TECHNICAL ADVISORY COMMITTEE REPORT

FILE NUMBER: 24-DP-24

SUBJECT: Preliminary Site Plan review for an approximately 2,490 SF Warehouse Building

WAREHOUSE METAL BUILDING
 6013 RODMAN STREET
 HOLLYWOOD, FL 33023

DRAWN	M.J.G.
CHECKED	D.J.A.
DATE	JULY, 2022
SCALE	AS NOTED
JOB. NO.	22-005
A-2.0	
OF	SHEETS

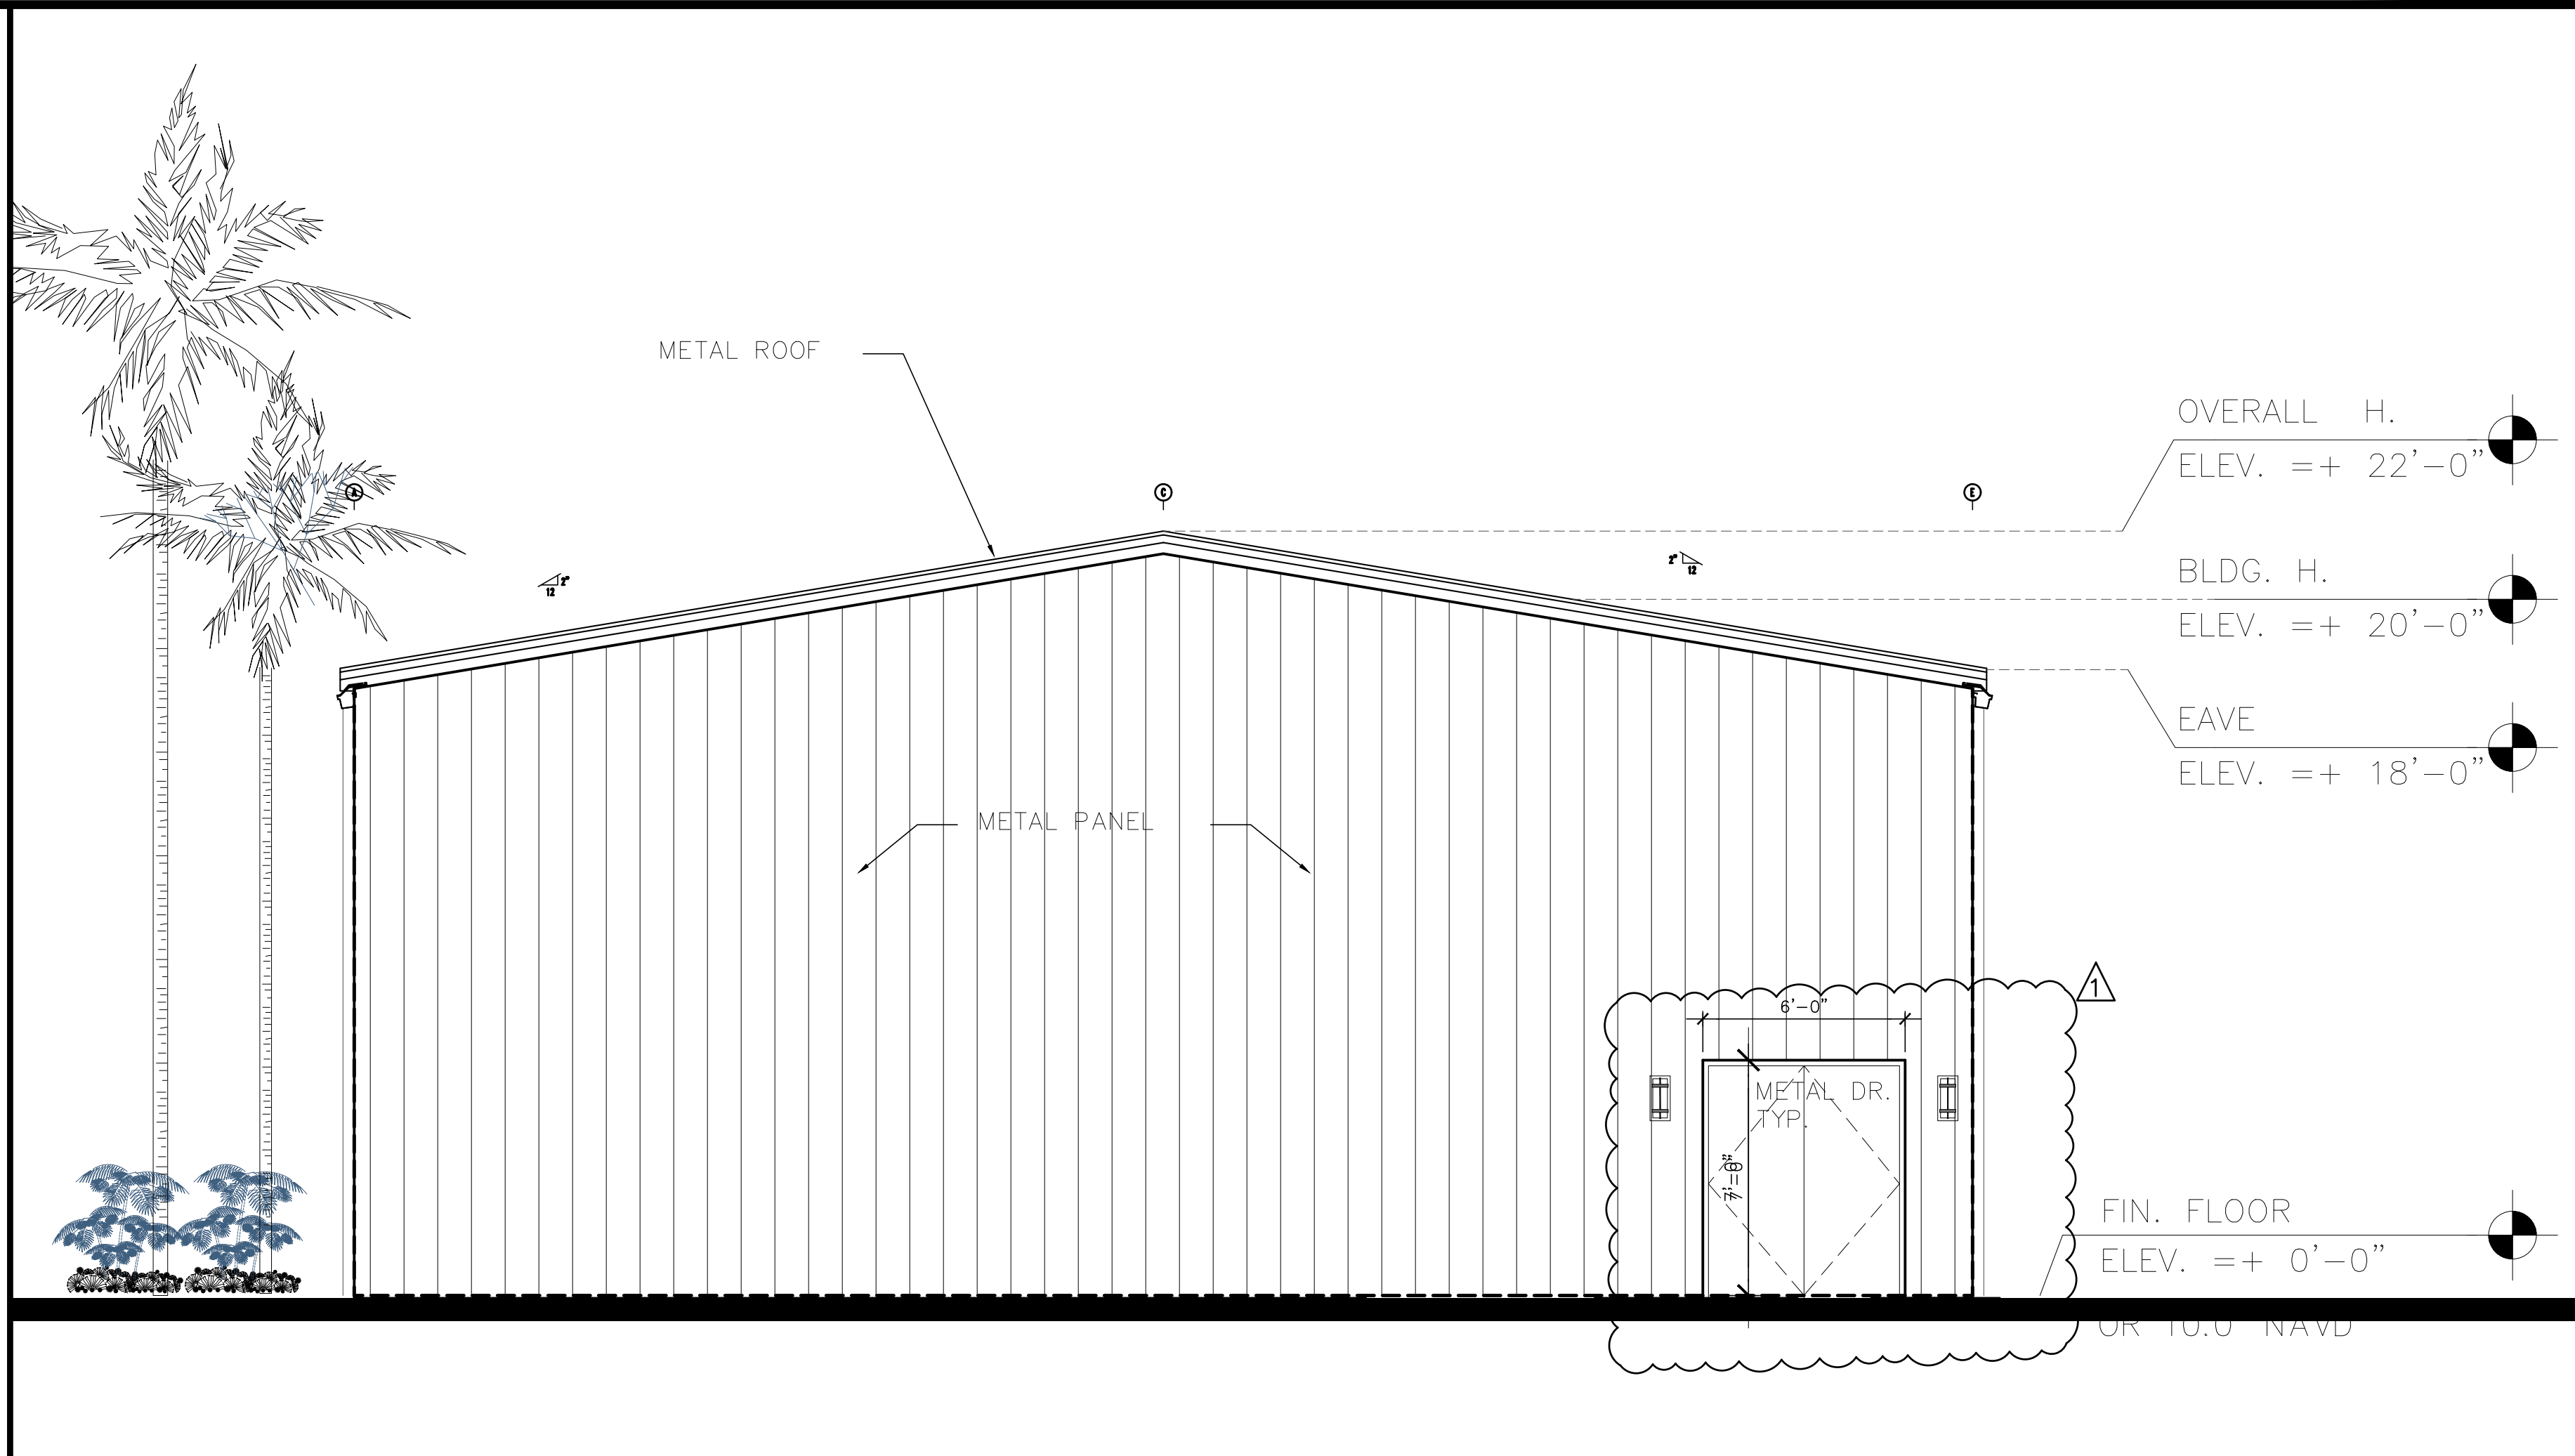
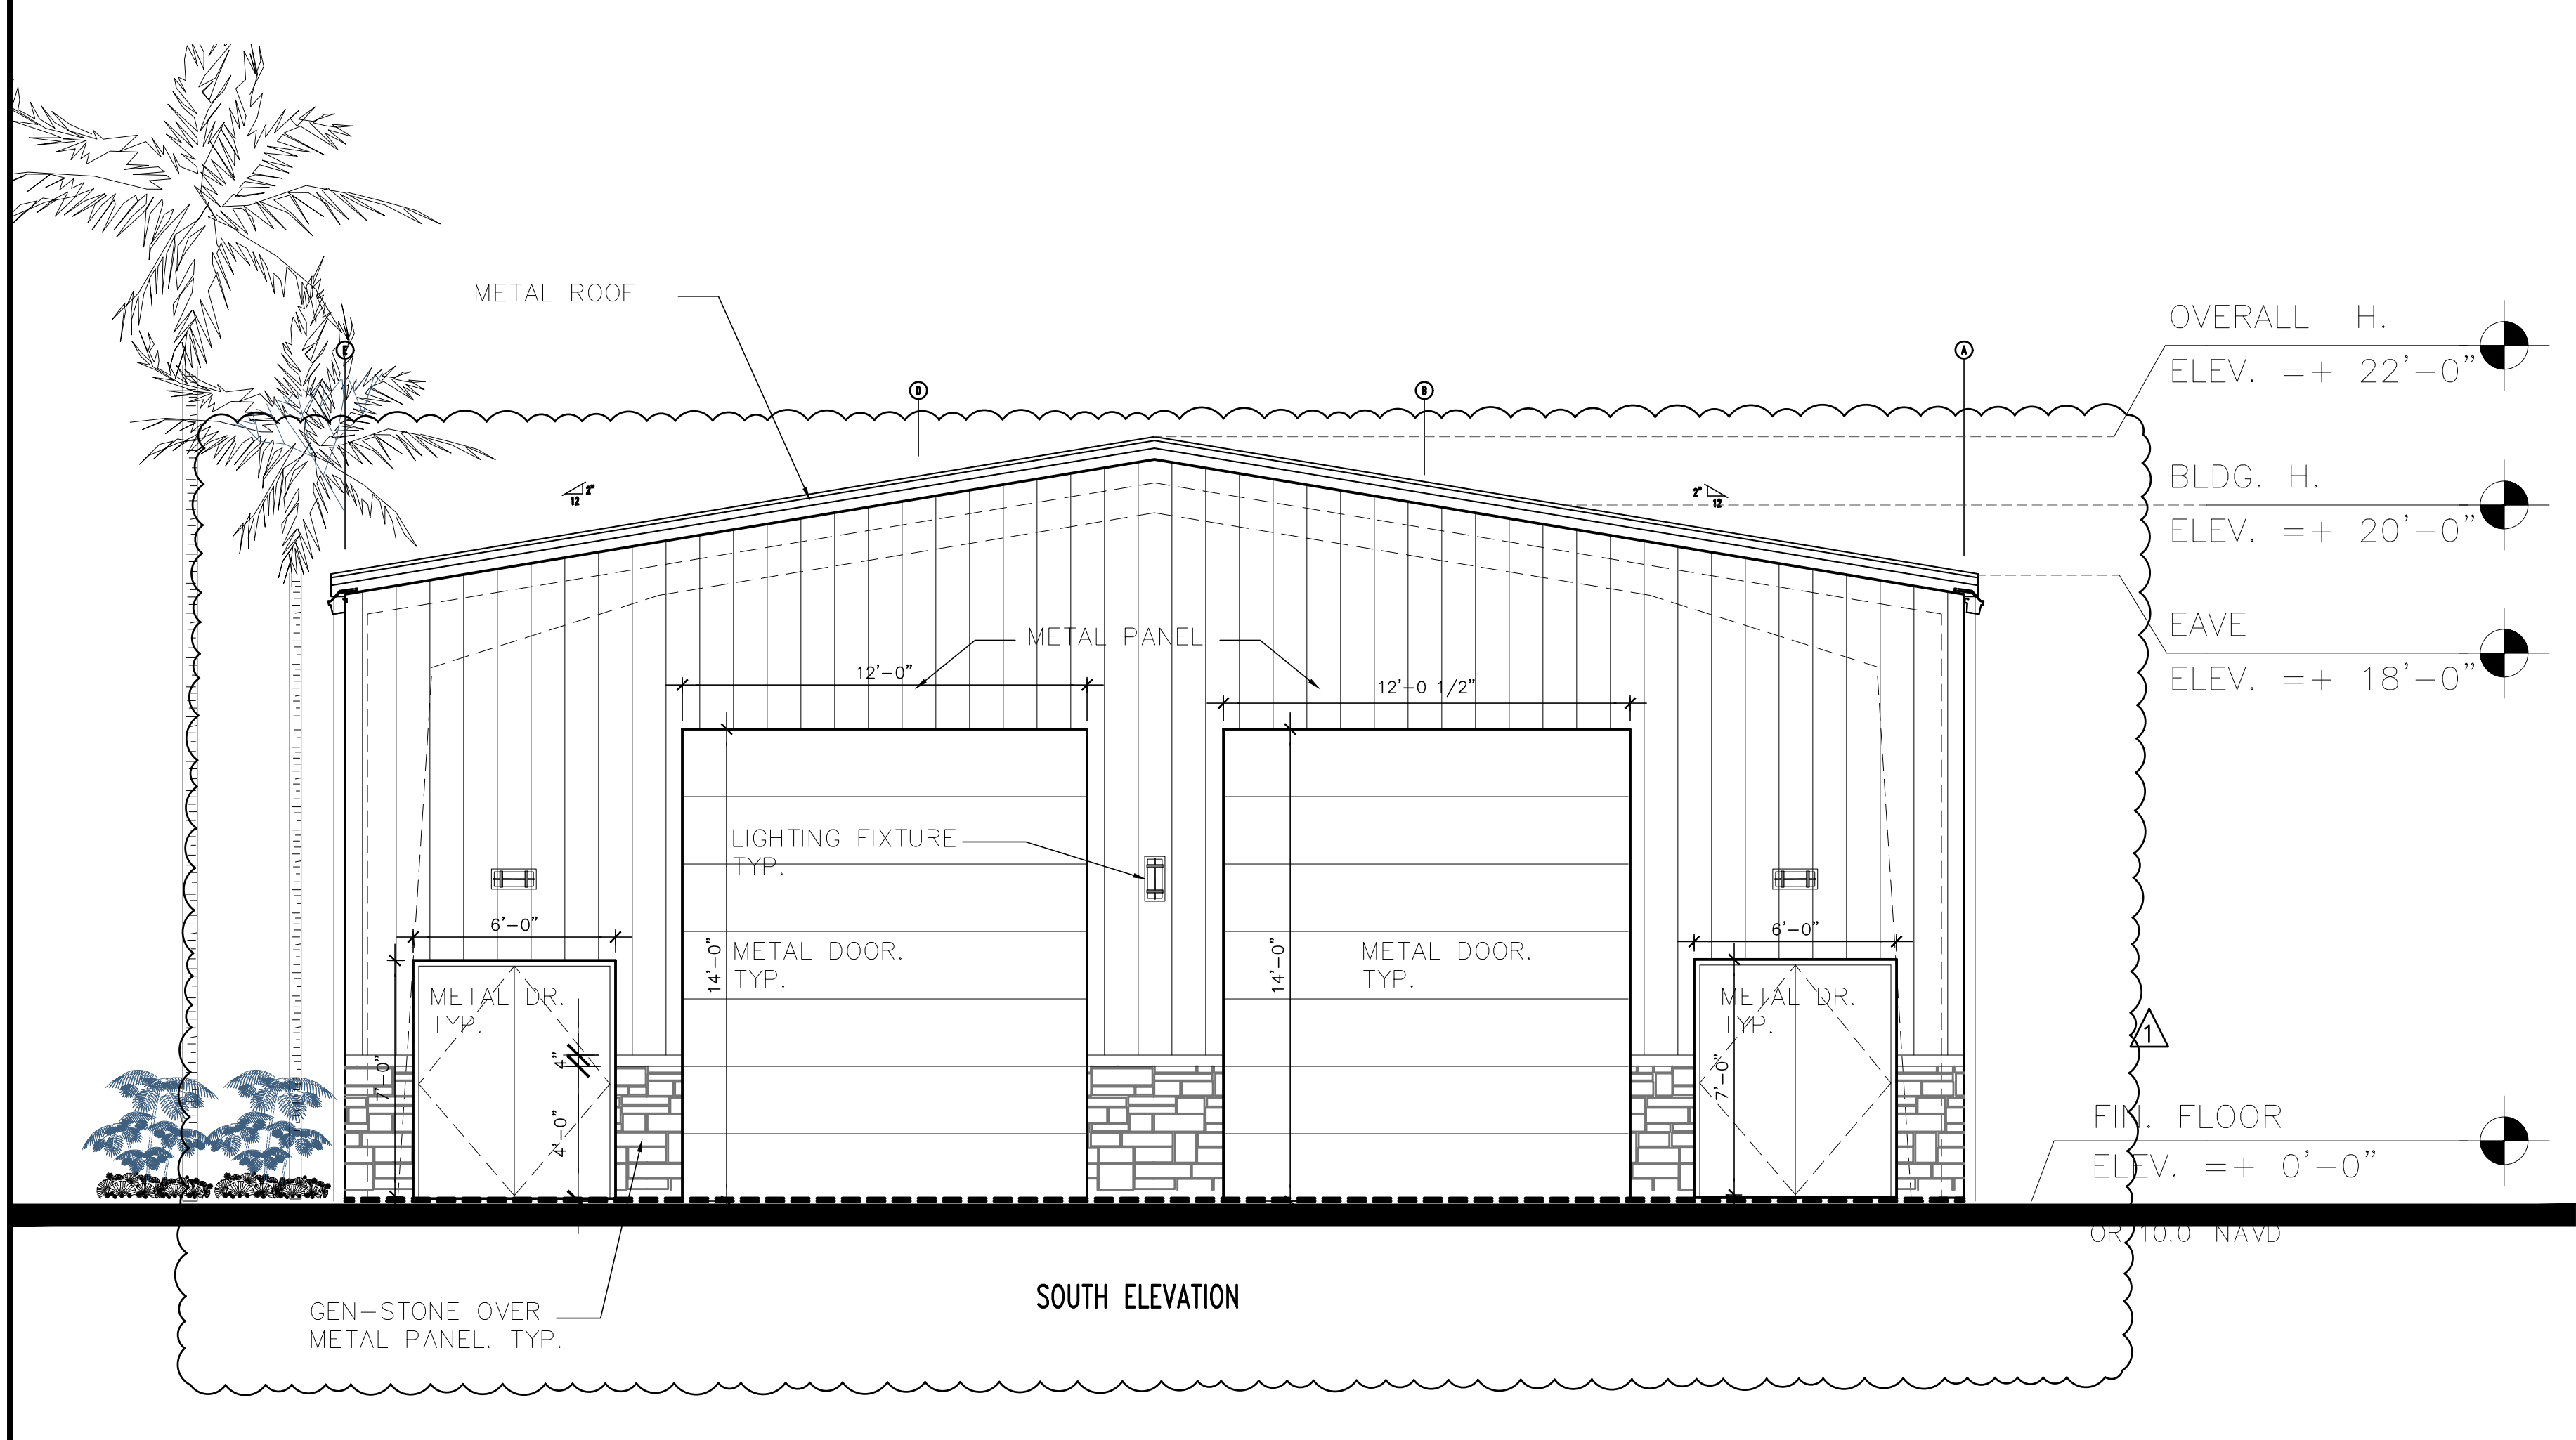
- 1. Provide material legend elevations. **PLEASE SEE MATERIAL SHOWED ON ELEVATIONS, A-2.0 AND A-2.1**

19. Add dimensions to the openings on the elevations on Sheet A-2.0 and on the site plan SP-1. **PLEASE SEE THE REVISED SITE PLAN SP-1 AND SHEETS A-2.0.**

20. Label the height of the entrances, exits, and doorways on the elevations on A-2.0. **PLEASE SEE REVISED SHEET A-2.0.**
21. Please clearly call out in the plans for swales to be restored along Rodman Street. This should be restored with grass to the City of Hollywood Typical Swale Grading Detail and Turf Restoration Detail, please include details in plan set. **A NOTE WAS ADDED TO THE PLAN C2.**
